Reference: **GOULBURN PERFORMING ARTS CENTRE**

ACCESS REPORT DEVELOPMENT APPLICATION

Project: Goulburn Performing Arts Centre
Document Type: Access Report – Development Application
Report Number: IAC-558

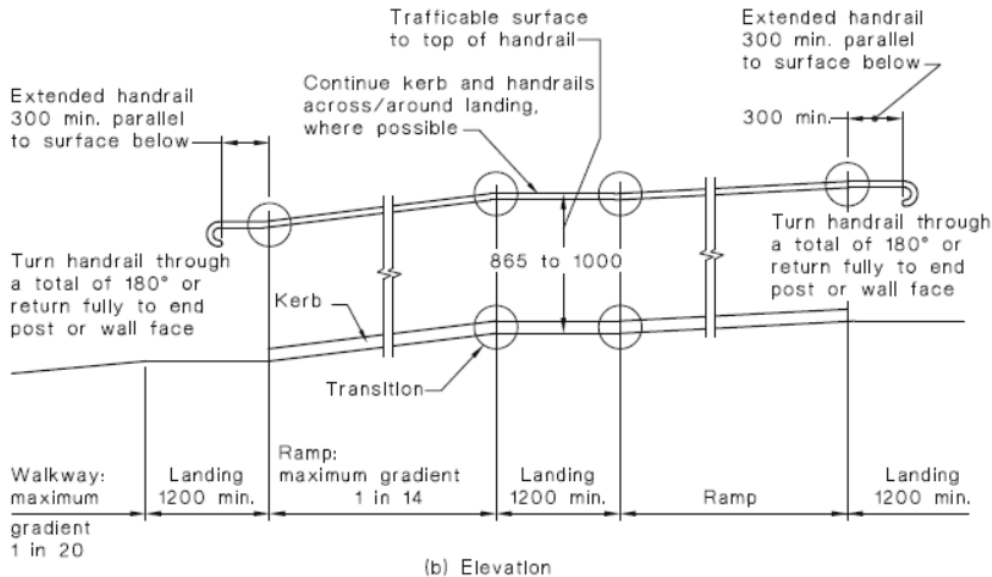
The gradient of the ramp system is nominated as 1:14. The maximum length of each ramp section is not to be more than 9m and a 1200mm min landing is to be provided between the ramp sections.

The bottom of the ramp is to be set in a minimum of 900mm from the boundary.

The detailing of the ramp will require compliant handrails, handrail extensions, kerb rails and the installation of TGSIs at the top and bottom of the ramp system. TGSIs are not required at the mid-landing position.

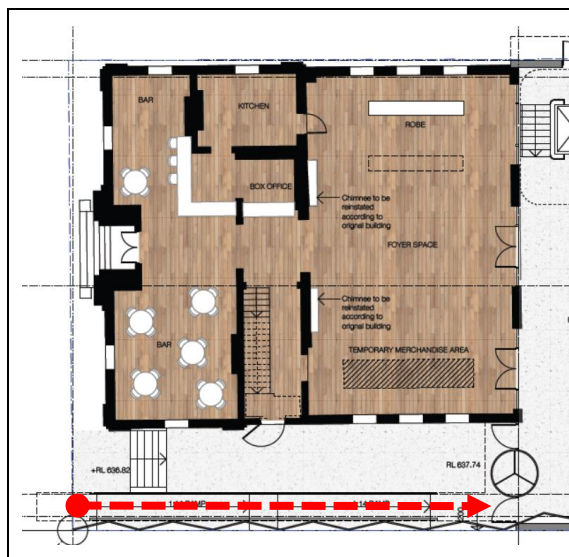
The sketches following indicate the accessible path of travel leading to the Principle Pedestrian Entry as well as an artist impression of the proposed entry to the new Performing Arts Centre.

Figure 4 Wheelchair Seating Positions – Stalls

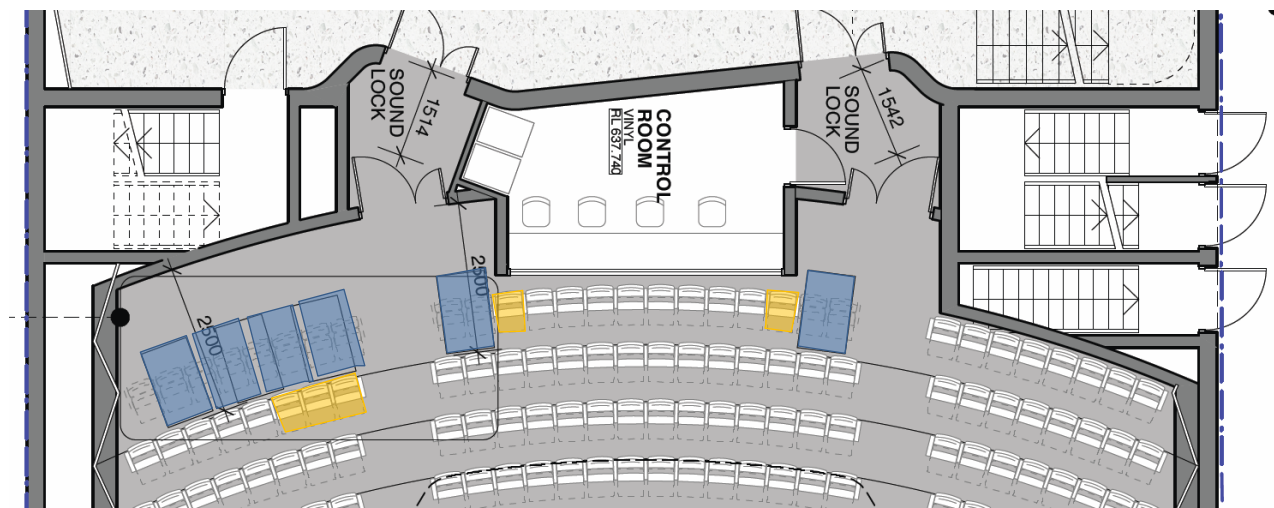
The design proposal proposes a total of 9 wheelchair locations made up of 6 accessible wheelchair positions as part of the stalls and 3 accessible seating locations provided within the Dress Circle area. In both instances compliance is achieved by the removal of fixed seating and the installation of platform.

Consideration will need to be given to the allocation of companion seating positions when all seating positions are allocated.

The extracts from the plans following indicate the locations of the accessible seating positions as well as the suggested positions of the companion seating. These layouts indicate the seating arrangement when there is a demand for all the accessible seating able to be provided.

Ticketing policies will need to be determined when deciding on the allocation of the number of wheelchair positions within the theatre.

Figure 8 Ground Floor Foyer

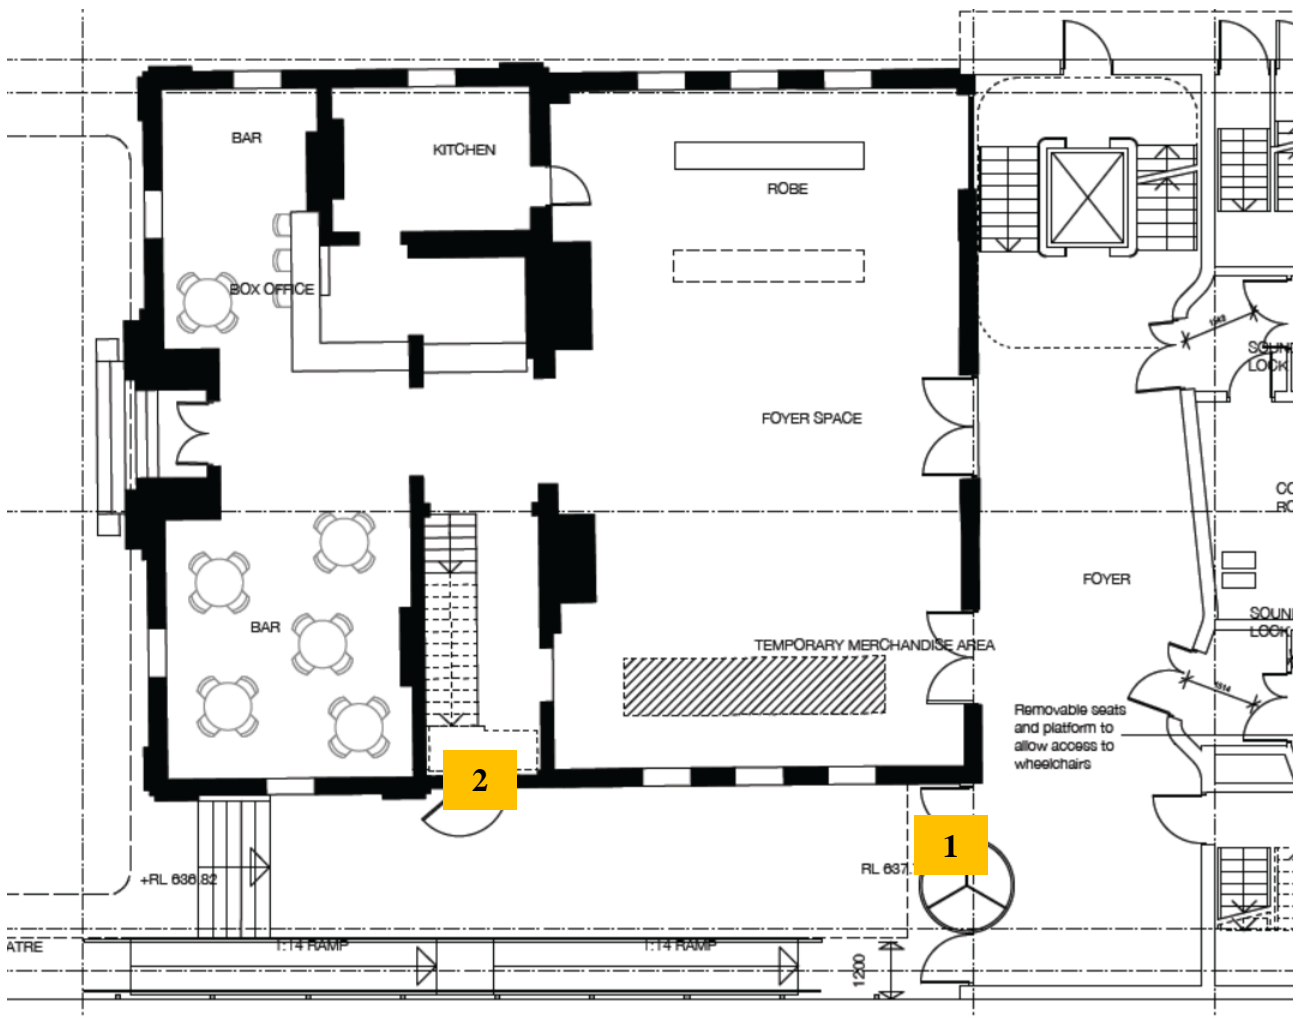
The Foyer, Box Office and Bar Space offers the opportunity for multiple activities to be undertaken. Functionally there are two (2) pedestrian entry points to the Goulburn Performing Arts Centre as indicated on the extract of the plan. On event days, the entrance to the facility is possible at location “1” and at all other times access to the facility is at location “2”. An intercom will need to be located at both entrance positions.

The floor finishes to these spaces has yet to be finalised.

If carpet is specified, then the specification of the construction of the carpet will need to satisfy the provisions of NCC Clause D3.3(g) and (h).

The plan proposes a central rotating door to access the Theatre Foyer. This type of door is not accessible friendly. The plan also indicates hinged doors on either side of the rotating door. The minimum clear width of these doors will need to be not less than 850mm and compliant latchside clearances (530mm) will need to be provided.

It can be assumed that this façade will be a glass façade. The detailing of the glass may require the application of visual indicators on the glazing to satisfy the requirements of Clause 6.6 of AS428.1:2009.
